24th August 2023

Our Ref: RMA/LC2402g_1 – EA Response Letter August

RE: PROPOSED REDEVELOPMENT OF LAND AT GROVE ROAD IN NORTHFLEET, KENT, DA11 9AX – ENVIRONMENT AGENCY RESPONSE LETTER (AUGUST 2023)

Our ref: KT/2022/129955/05-L01
Charged agreement ref:
ENVPAC/1/KSL/00566
Date: 29 June 2023

Typical Section ZZ @ 1:500

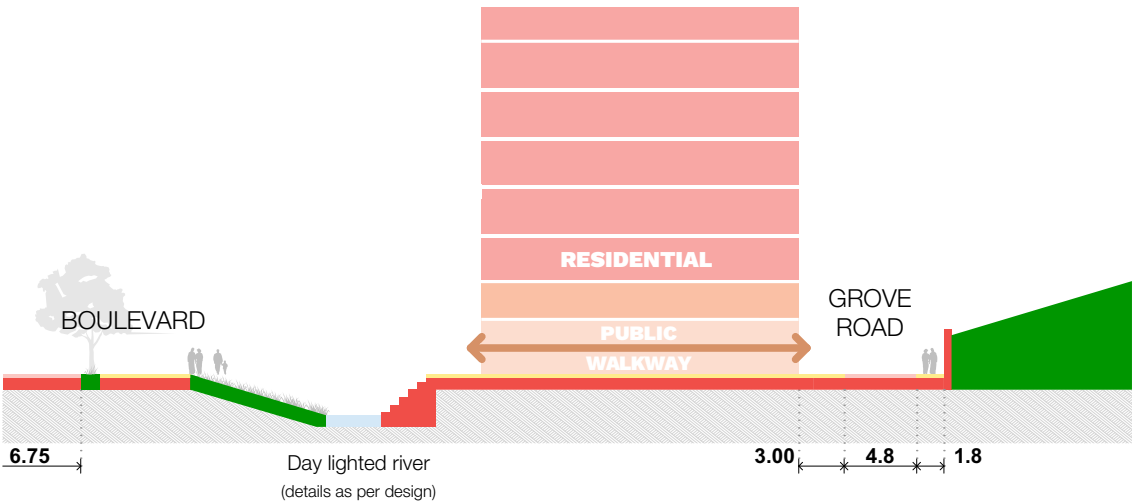
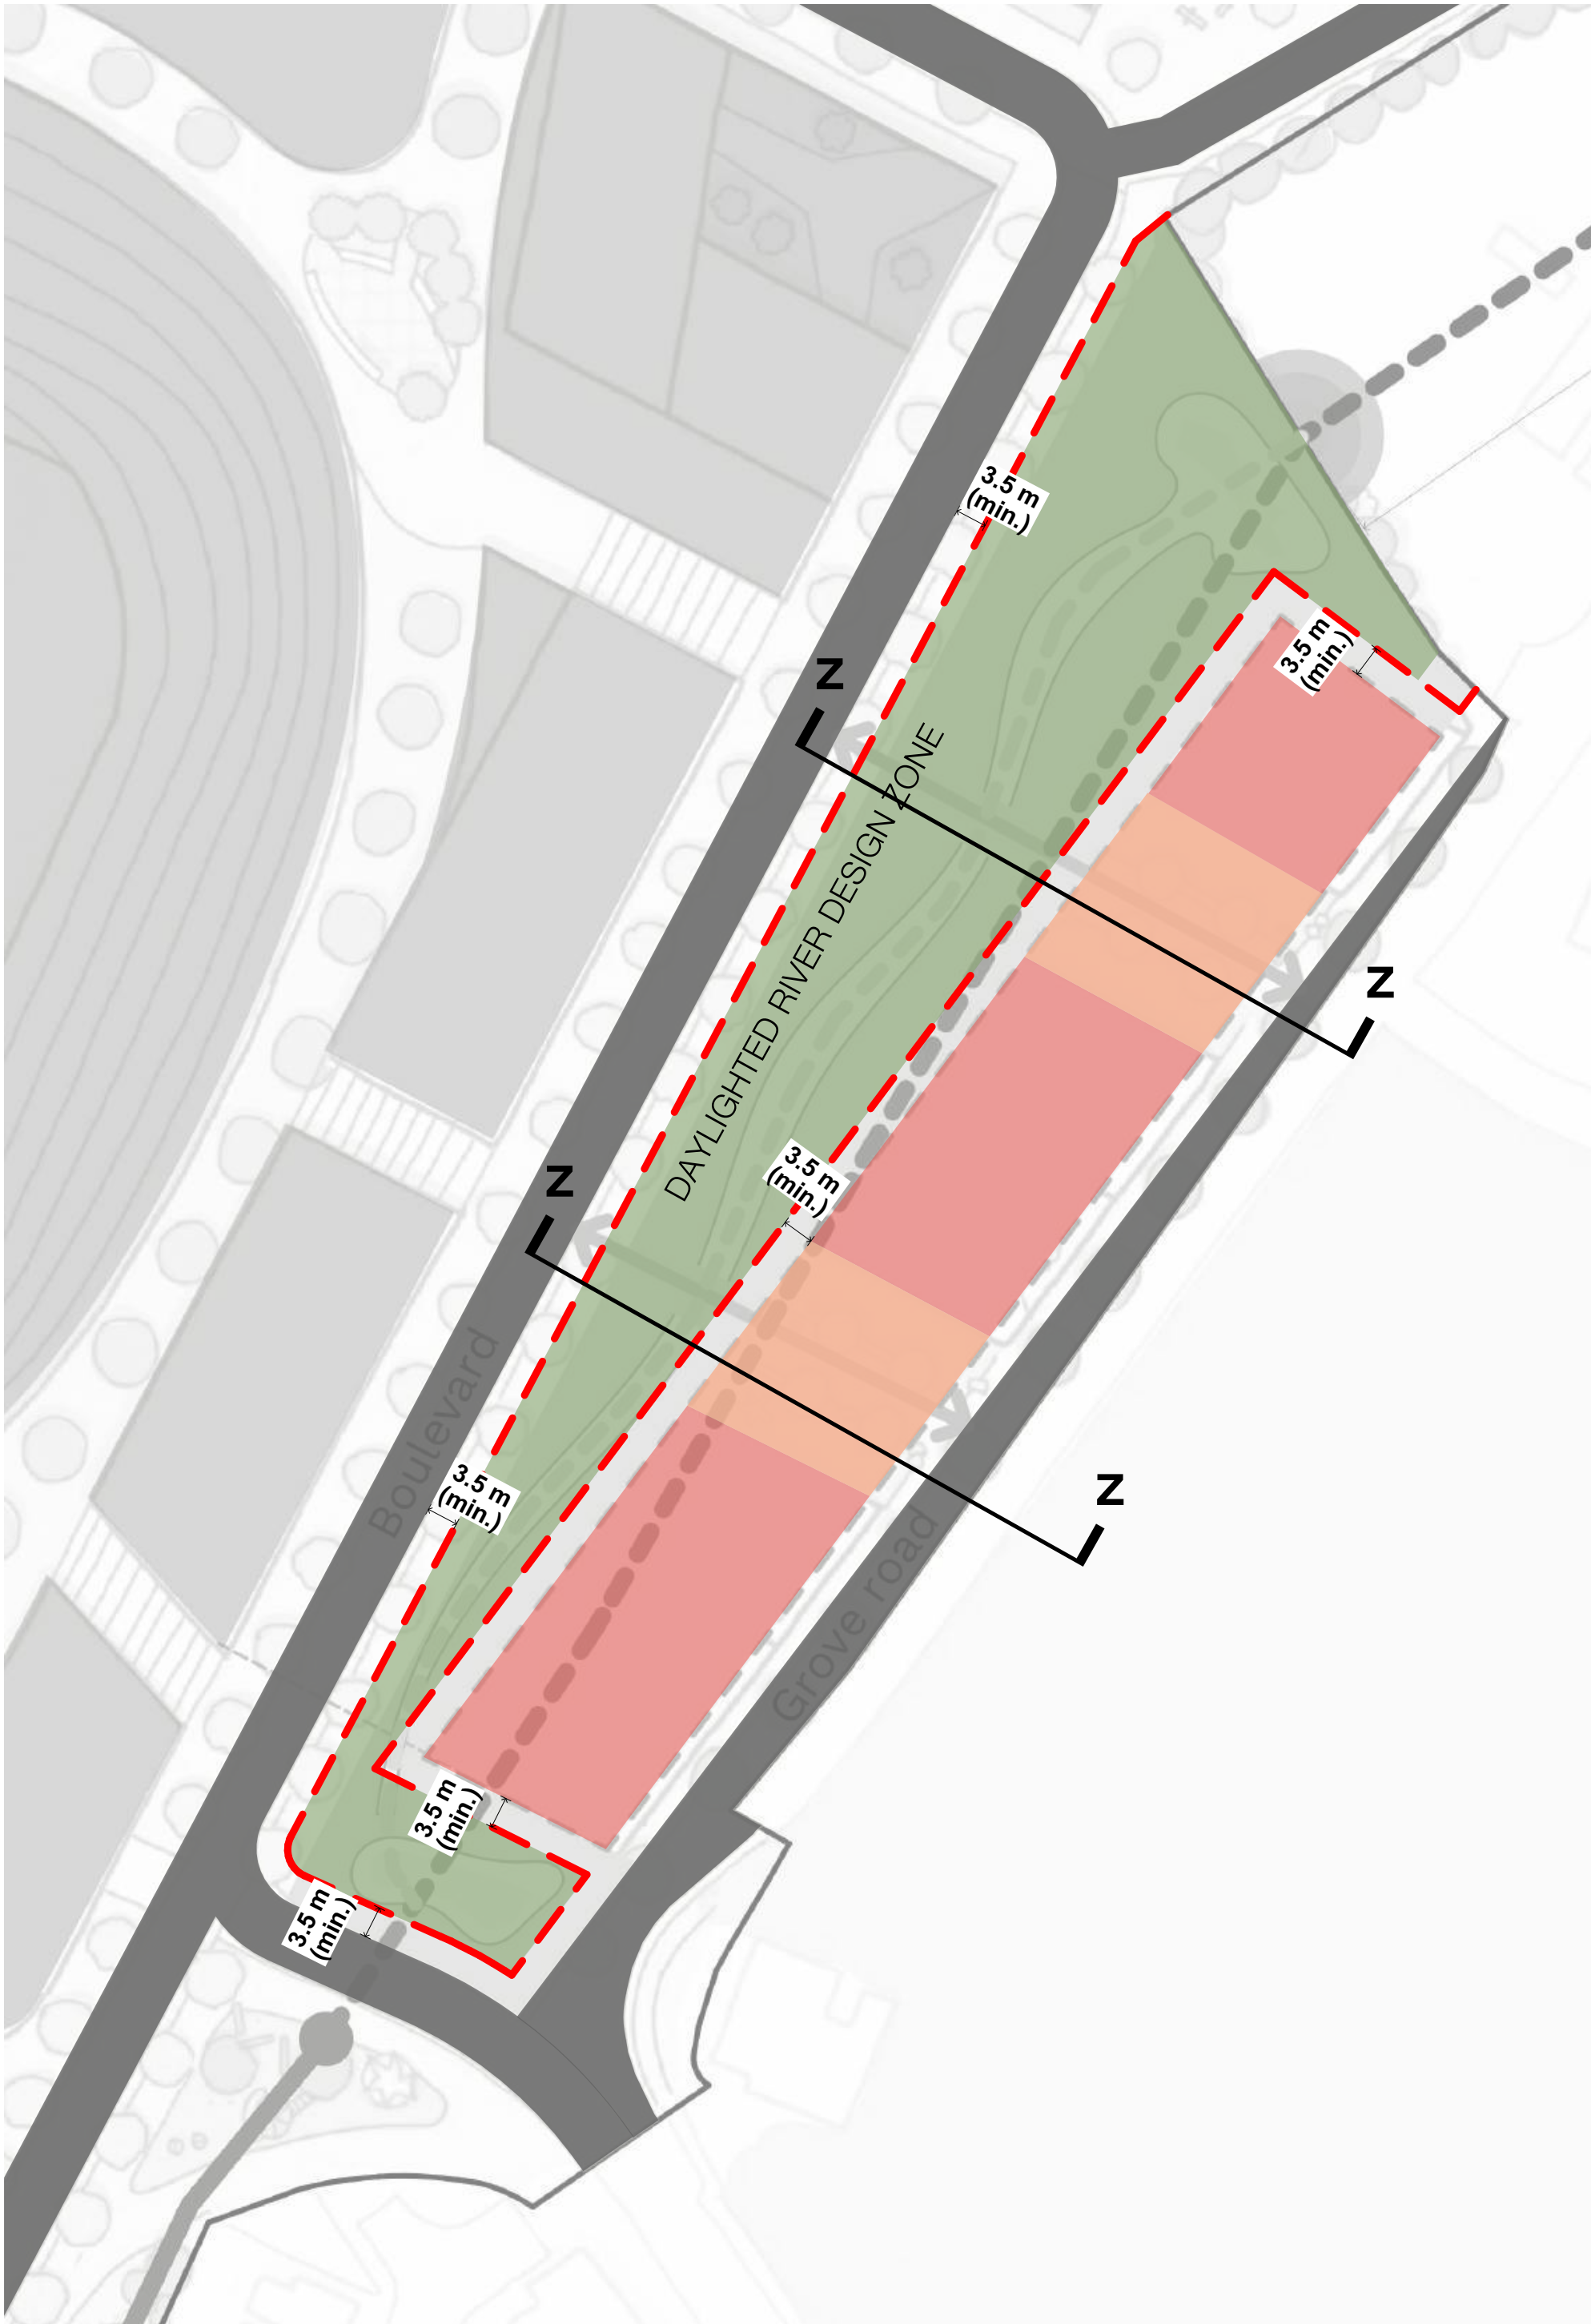
"It should be noted that we are seeking for the entirety of the Main River Ebbsfleet to be de-culverted (allowing for free spanning bridges and short sections of culvert as required). We understand that a section of culvert runs next to the A226 which is within the site boundary, and this should be included in any de-culverting proposals. Any section of culverted main river would need to have a 100-year design life as part of the proposed development. This is to ensure that the lifetime of the culvert is

“Whilst the option of a cantilevered path was discussed with our biodiversity officer during the meeting, we would like to highlight that we would likely oppose a cantilevered path from a flood risk perspective given this would significantly negatively impact future maintenance and management of assets required for flood risk management.

It was queried at this stage of the meeting what level of detail would be required in order for us to request a condition on the outline application detailing the design of a deculverted channel. Whilst it is difficult to say at this stage of the design, we stated that any condition we request would need to pass the 6 tests for planning conditions as outlined in the National Planning Policy Framework (NPPF) <https://www.gov.uk/guidance/use-of-planning-conditions>. A sufficient level of detail needs to be provided for us to be request conditions that pass these tests”.

HLM Architects prepared a Proposed River Daylighting Sections plan and Proposed Daylighting Zone plan which shows the indicative daylighted river location and cross-sections within the site (refer to Appendix D). These plans show that the majority of the River Ebbsfleet within the site is proposed to be daylighted, there is a small section of the channel to the south of B2175 that will remain within the existing culvert. It will be ensured that the culverted section within the site will be maintained throughout the operational lifetime of the development and if required the culvert will be increased in size to accommodate the flows during the design flood flows, subject to the results from the flood modelling.

The buildings adjacent to the watercourse have been moved to the east to provide space for daylighting the culvert and the indicative daylighted sections will comprise of landscaped banks, stepped banks and walls in order to accommodate the daylighted section within the layout. A minimum easement of 3.5 m from the top of the banks of the watercourse to the buildings would be provided in line with the EA's suggestion during the meeting that *‘the maintenance buffer of 8 m could be reduced if the river is daylighted’*. A maintenance access of over 8 m can be provided on the western side of the daylighted culvert which includes the boulevard and, therefore, the River Ebbsfleet can be maintained from this side. Additionally, sections of the proposed buildings to the east of the daylighted culvert will comprise of public walkways at ground level which will provide an increased easement from the watercourse in these areas and will be open across two levels, which can allow for vehicles to enter from the east should this be necessary (refer to the indicative cross sections shown within Appendix D). The details of the deculverting is subject to the flood modelling results to ensure that the proposed works will not increase flood risk within the site or elsewhere.

It is not proposed to include a cantilevered path within the proposed layout. The Proposed River Daylighting Sections plan and Proposed Daylighting Zone plan have been submitted to provide details on the deculverted channel and it is considered that for this outline application any further details could be conditioned.
